**FEDERAL COMMUNICATIONS COMMISSION**  
Equipment Authorization Division, Application Processing Branch  
7435 Oakland Mills Road, Columbia, MD 21046  
Telephone: (301) 725-1585, ext 230 Facsimile: (301) 344-2050

This is in response to your fax dated July 19, 1996. From the information provided, it appears that the proposed antenna connector does comply with Section 15.203.

FAX MESSAGE		
Cy :	Lucent Technologies	Fax no : 030-6097556
Attn :	mr. Wilbert Smorenburg	Date : 18.07.96
Dept :	WCND	Copy: F. Vauthelin, Radiall S.A.
From :	M. Teeuwissen	Paris
Subject / Reference :		FCC requirement for MC-card series

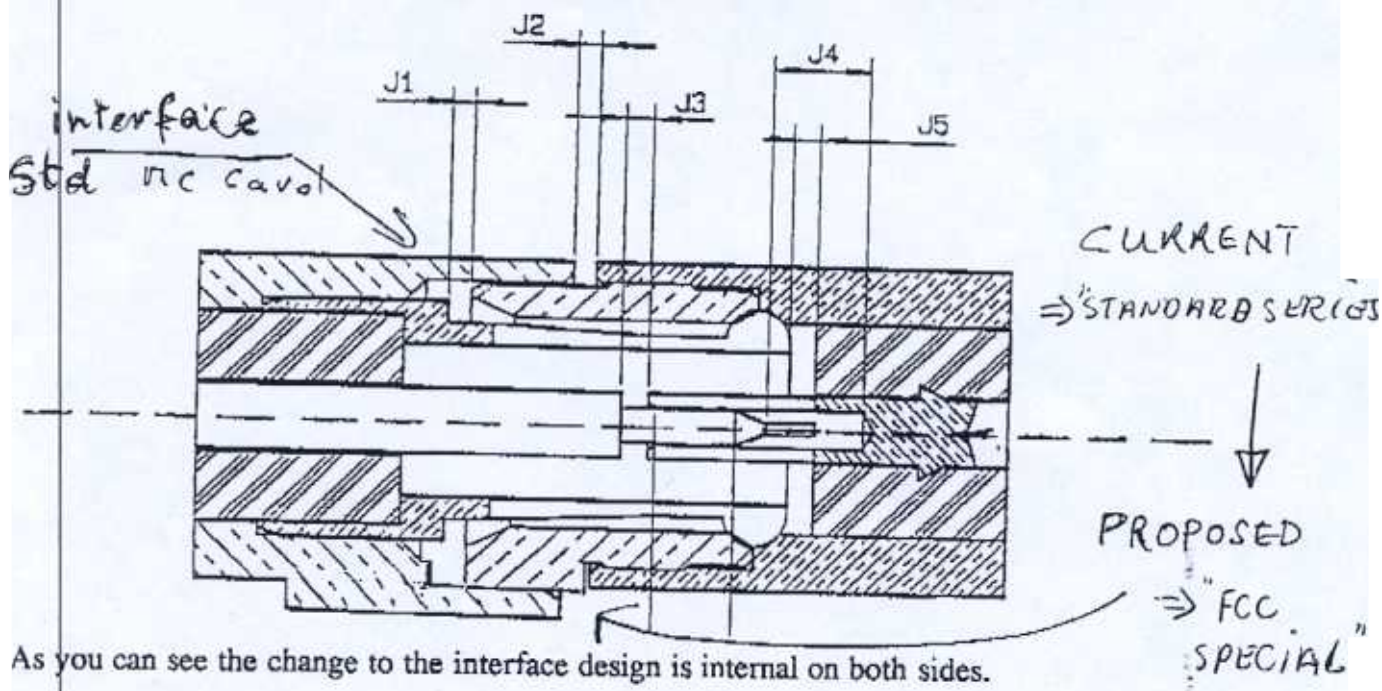
further to our conversation just now please find enclosed the explanatory sketch, which will make the difference between current and proposed situation clearer:

As you can see the change to the interface design is internal on both sides.
